EAGLE MOUNTAIN CITY
PLANNING COMMISSION MEETING AGENDA

Planning Commission Staff Report

Project: **SilverLake 14 & 15 – Preliminary Plat, Site Plan**
Applicant: Nate Hutchinson – Flagship Homes
Type of Action: Action Item (Recommendation to City Council); Public Hearing

Proposed Townhome Elevation - Front

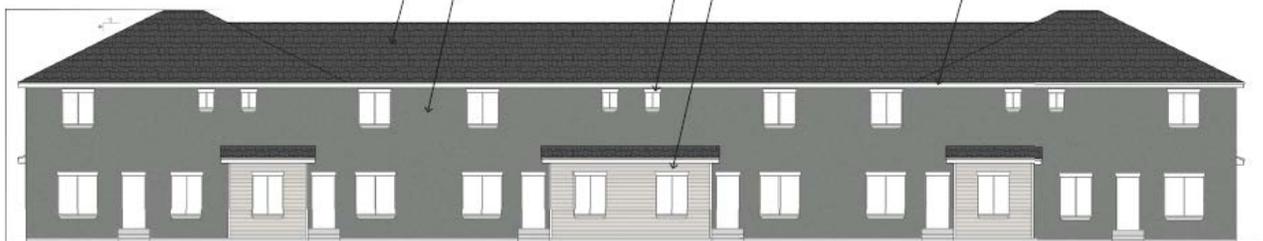
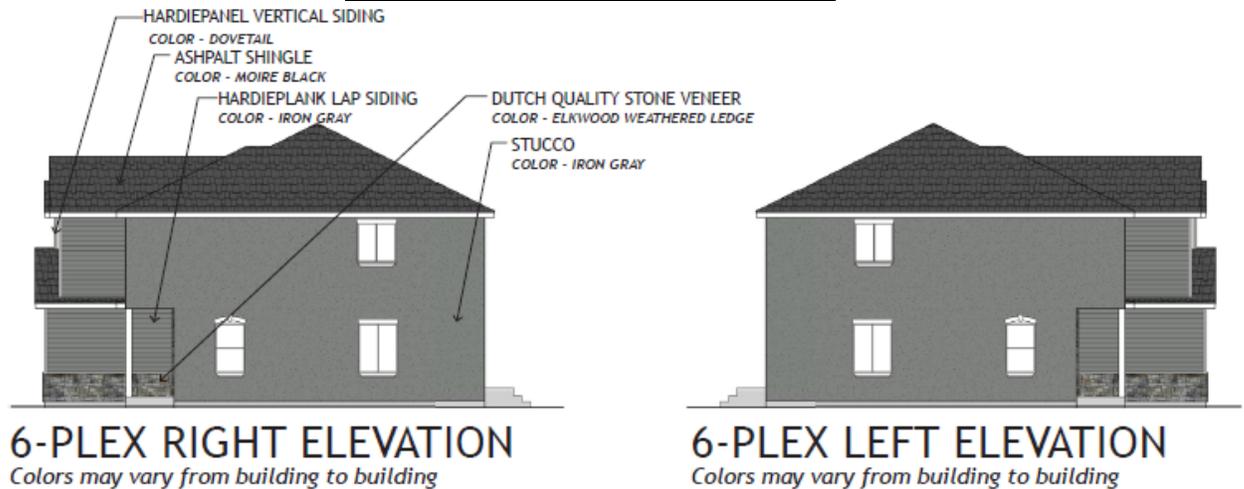
6. Townhome Elevations/Exteriors & the Multi-Family Design Standards

Section 5g of the SilverLake Master Development Agreement states the following:

The exteriors of each of the new MFR dwellings shall contain masonry materials, including stone, brick, and fiber cement siding, hardy board or similar product as fundamentally depicted on the renderings in Exhibit C-2. Stucco may be used as a primary exterior material, provided that the stucco shall not exceed 25% of any front elevation and elevation facing a public street. No vinyl siding shall be permitted on any new MFR dwelling. MFR dwellings are expected to be built substantially compliant with the design and materials as represented/depicted on the renderings included as Exhibit C-2.

Several of the townhome buildings will have the rear elevation facing Woodhaven Boulevard, and quite a few of the buildings will have side elevations facing a public street. These elevations must be redesigned to only include no more than 25% stucco.

These townhomes are also required to comply with the City's Multi-Family Design Standards, Chapter 17.72 of the City Code. Here are some of the areas of concern from the standards in relation to this project:

Multifamily Building Orientation. Multifamily developments often have buildings facing onto internal courtyards and open space. The buildings adjacent to streets, however, shall front those streets and provide a primary entrance toward the street. If the side of a building faces a street, an entrance should be provided on that facade. Blank walls and/or rear facades should not be placed adjacent to streets. Orienting the primary entrances to a courtyard or open space without addressing the street-facing facade with entrances, windows, awnings, increased architectural elements, increased landscaping, and/or other pedestrian-oriented features is prohibited.

Multifamily Parking/Garages. Garages and parking areas should be placed to the rear of buildings, accessed by a service drive. If garages are placed on the front facade, they shall be staggered and set back so as to minimize their appearance from the street. Garages shall never dominate the street-facing facade of a building.

Building Articulation. Vertical and horizontal articulation and relief reduces the perceived scale of buildings. Buildings shall include facade modulation (stepping portions of the facade), horizontal and vertical divisions (textures or materials), window patterns, offsets, recesses, projections, and other techniques to help identify individual residential units in a multifamily structure, and to avoid large, featureless and/or panelized surfaces on commercial buildings. Large uninterrupted expanses of a building wall are prohibited.

Architectural Detailing. Multifamily buildings shall incorporate a majority of the following architectural detailing: decorative shutters, bay windows, popouts, trellis or arbor structures, porches, decorative gables, dormer windows, exposed timbers, balconies, columns, turrets, decorative trim and moldings, detailed grilles and railings, architectural lighting, decorative masonry pattern, window grids, and decorative doors and windows. All sides of a building shall include the chosen details, where applicable.

Multifamily Garage Doors. Garage doors shall not be the most prominent or visible feature on a building. They shall be accessed from the side or rear, or set back from the front facade. If garages are visible from the street, white doors are discouraged. Decorative doors are encouraged.

EXHIBIT 'A1' MASTER DEVELOPMENT PLAN MAP

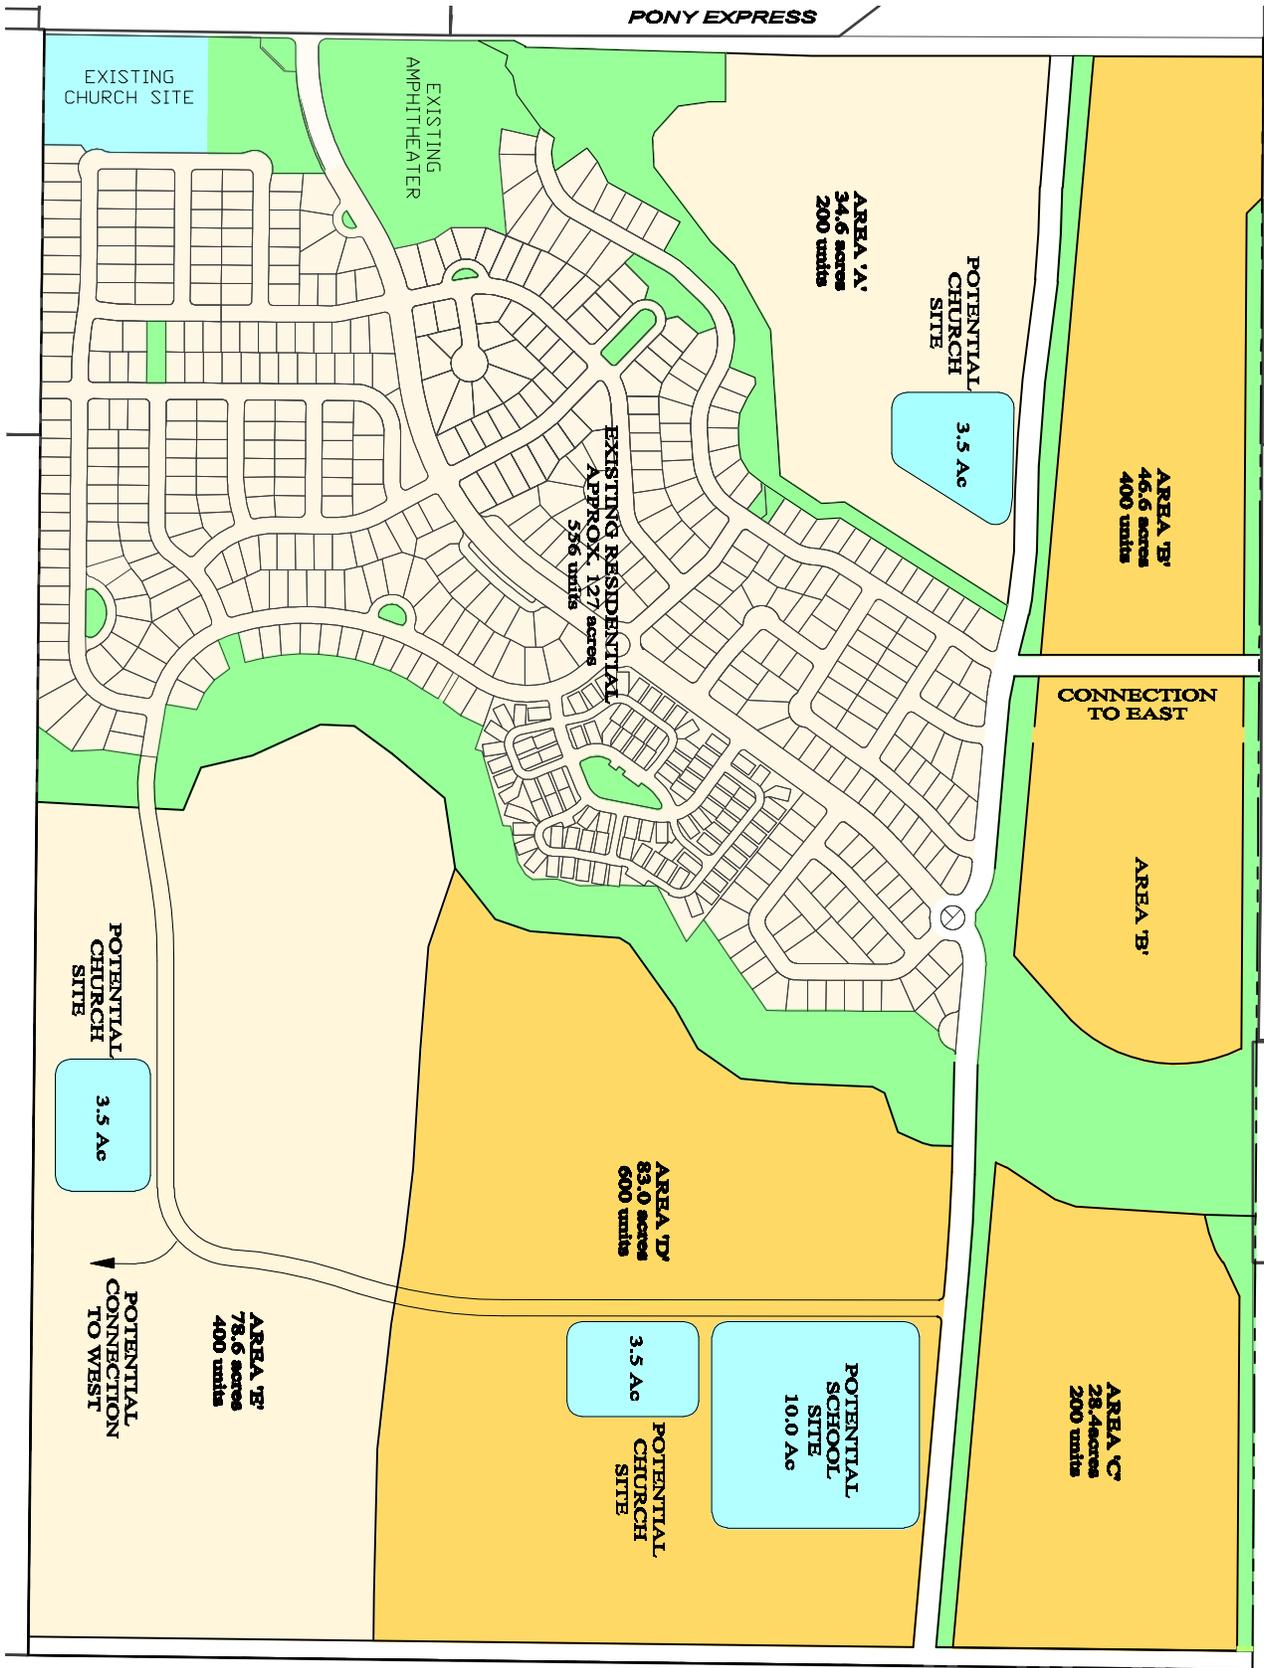
4. Lot Distribution. Does the distribution of these cluster home lots meet the required spacing/distribution in the SilverLake Master Development Agreement?

PGC (patio, garden court, cluster) homes must be distributed in areas identified on the master plan map, Exhibit A1. PGC (lots under 5,500 square feet or with a lot frontage of less than 55 feet) shall not be clustered together in groups of more than 65 lots.

These lots are located close to those in SilverLake plat 13, although there is a minor collector road separating the two developments. You will have to decide if the intent of the master development agreement language is met with this proposal, or if the configuration should be modified.

5. Townhome Distribution. Does the plan for 60 townhome units on each side of the park/open space meet the distribution requirement in the SilverLake Master Development Agreement?

MFR homes (townhomes) must be distributed in areas identified on the master plan map, Exhibit A1, and shall not be clustered together in groups of more than 65 lots.

This development includes 120 townhome units in total, divided into two groups of 60 with a small park in between. Does this meet your interpretation of the 65-lot distribution requirement?

EXHIBIT 'A2' OPEN SPACE MAP

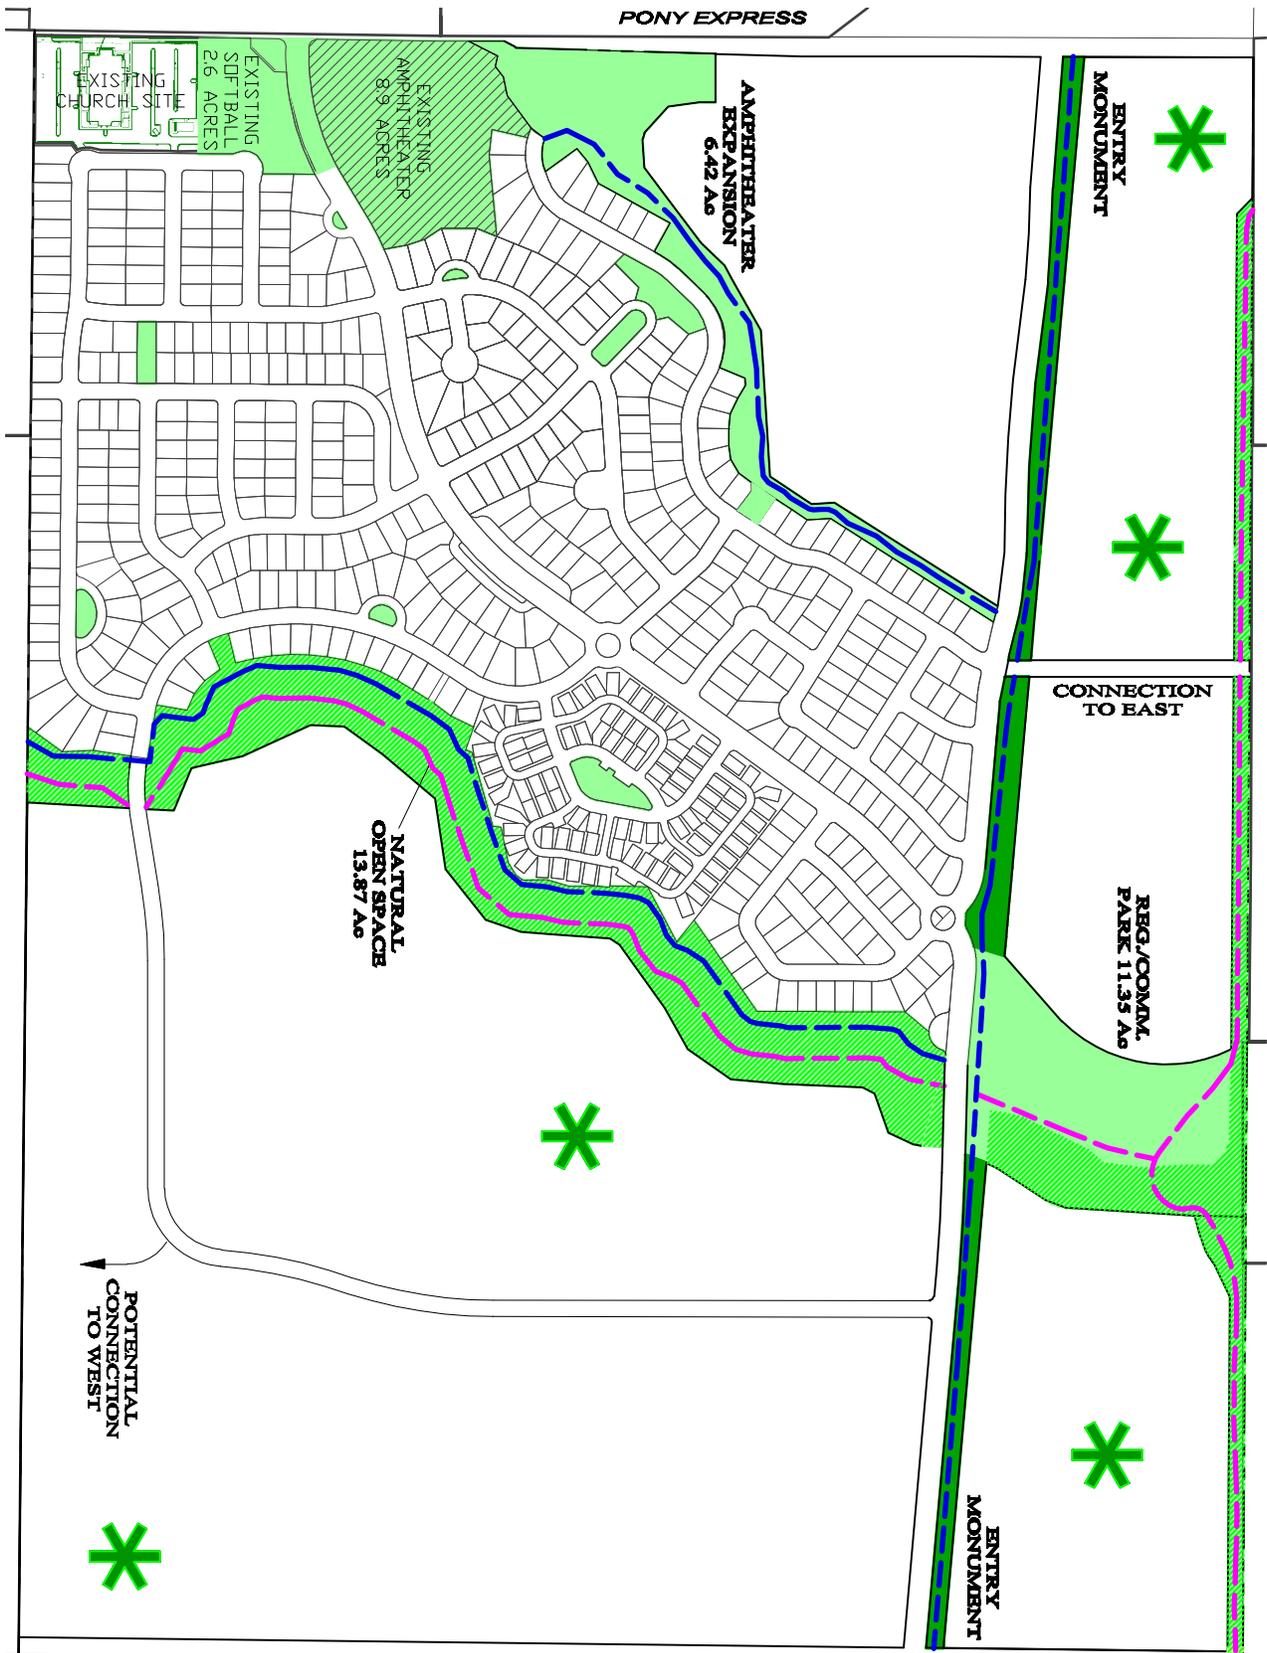
11. Community Park. Is it configured appropriately for the best usability and benefit to the SilverLake community and the City's recreation programs?

The SilverLake Master Development Plan parks and open space exhibit shows an 11.35-acre community park in this area. The proposed plan includes a 13.18-acre park (including the trail system underneath the power line corridor). This land will be graded and dedicated to the City with the first subdivision plat in this development. Is the park's location and configuration appropriate for the best usability and benefit to the SilverLake community?

Park Amenity List

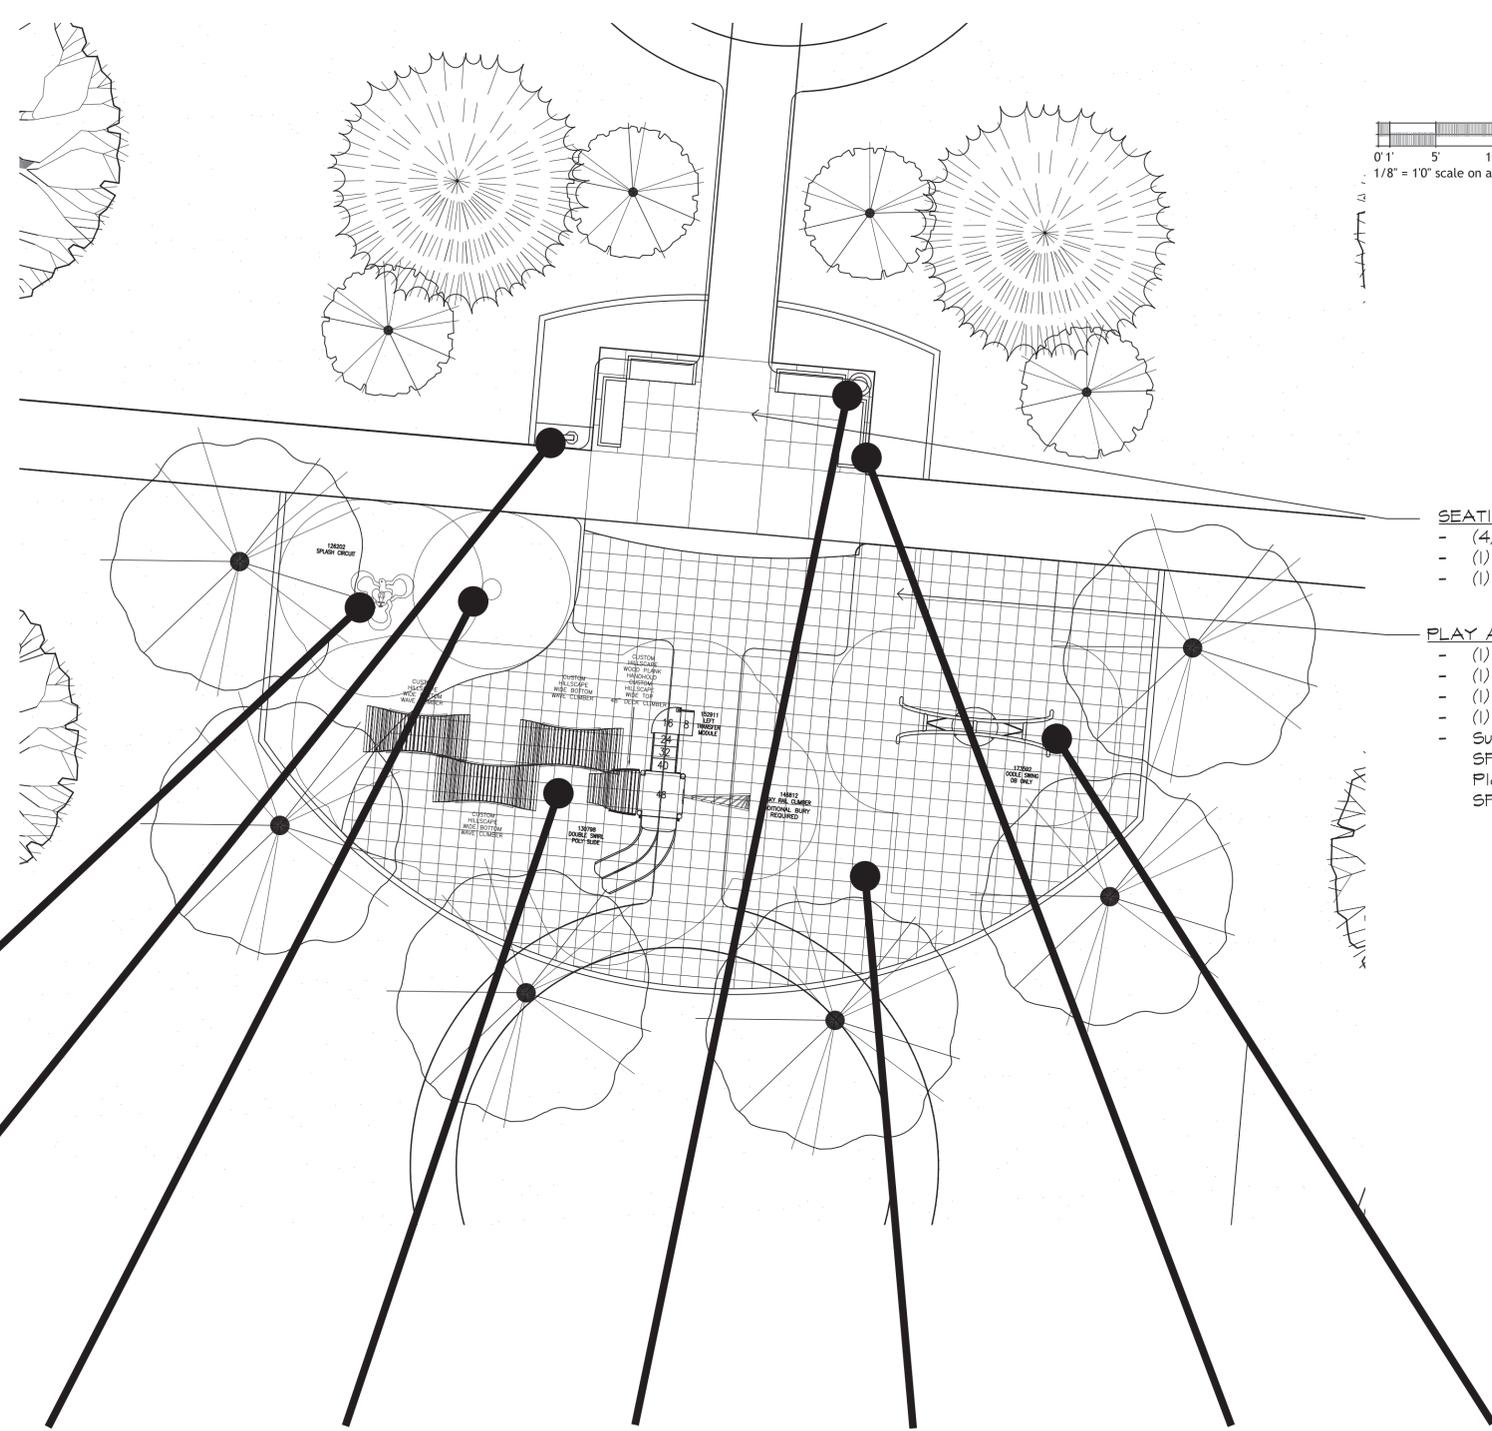
13. Landscaping / Parks. Have the developers provided the required point values for improved open space? Do you agree with the proposed amenities and point values?

- 2.85 acres x 70 points = **200 points**. See the submitted table below for the developer's proposed breakdown of amenities/improvements and the associated point values.

Please provide your feedback on the proposed amenities. We recommend that a revised landscape plan be submitted that provides 200 points and a compelling explanation be provided by the applicant for the "high efficiency irrigation system" points.

6-PLEX FRONT ELEVATION

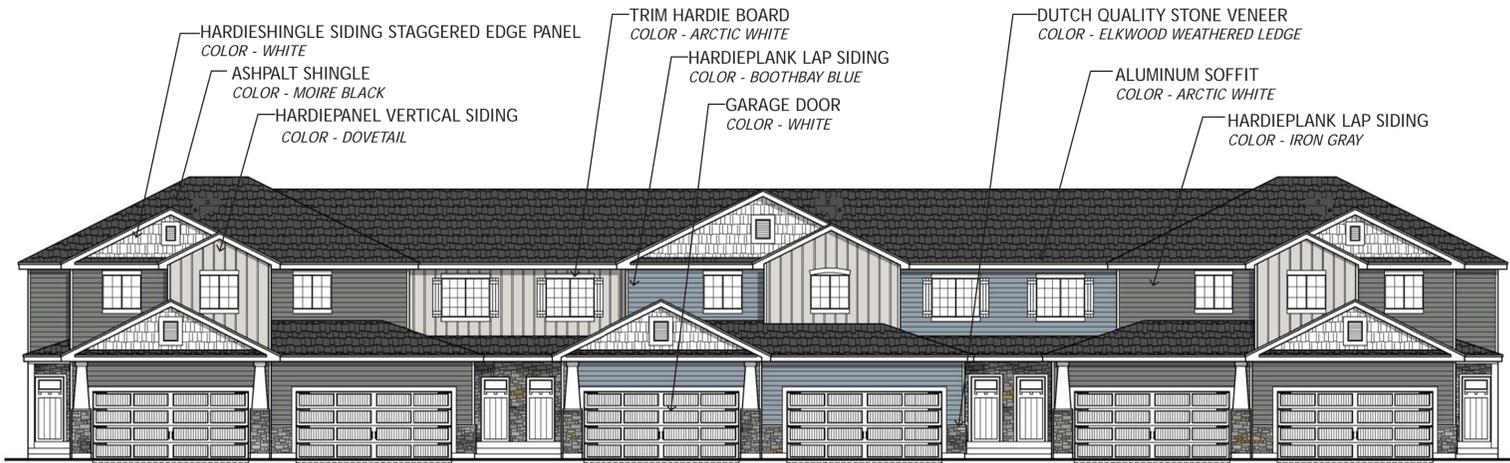
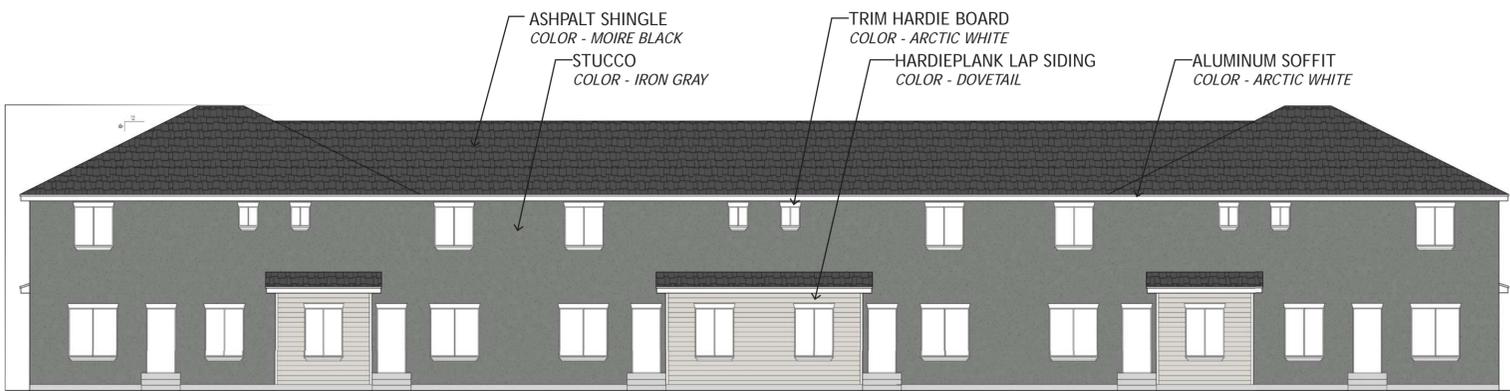
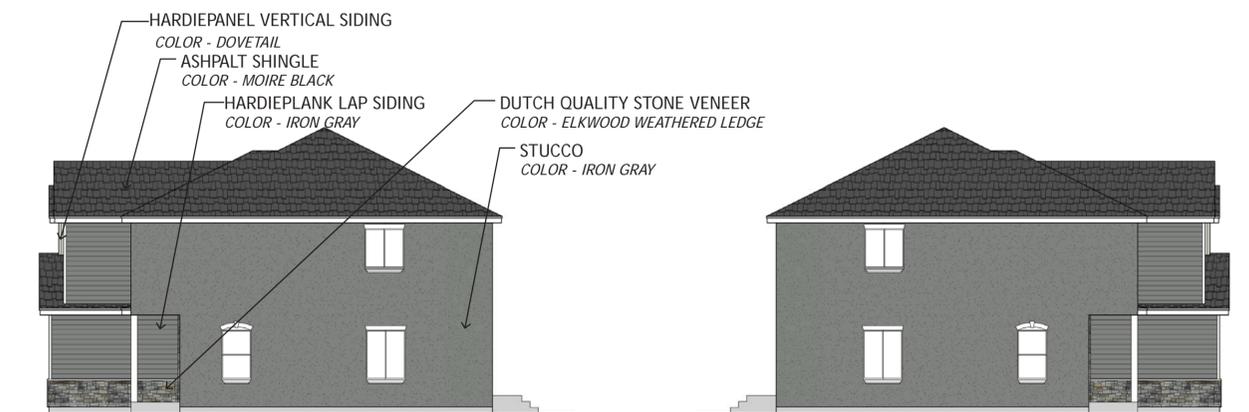
3. Cottage Home Elevations. Do the building elevations of the cluster or cottage homes meet the standards found in the SilverLake Master Development Agreement? Do you want to review the cottage home elevations as part of the site plan review?

The exteriors of each of the new PGC (patio / garden court / cluster) homes shall contain masonry materials, including stone, brick, and fiber cement siding such as hardy board, or similar product, as fundamentally depicted on the renderings in Exhibit C-1. Stucco may also be used as an exterior material, provided that the stucco shall not exceed 25% of any front elevation and elevation facing a public street. Such masonry materials shall be “wrapped” onto side exteriors a minimum of 18 inches from the front elevation. No vinyl siding shall be permitted on any new single family residential dwelling. PGC dwellings are expected to be built similar to and substantially compliant with the design and materials as represented and depicted in the renderings included as Exhibit C-1.

You can either require that the specific home plans or building elevations are reviewed by you (the Planning Commission) for approval, or you can allow the Staff to review the building elevations at building permit to make sure that they comply and are similar in style to the elevations in Exhibit C-1 (we will show these at the meeting).
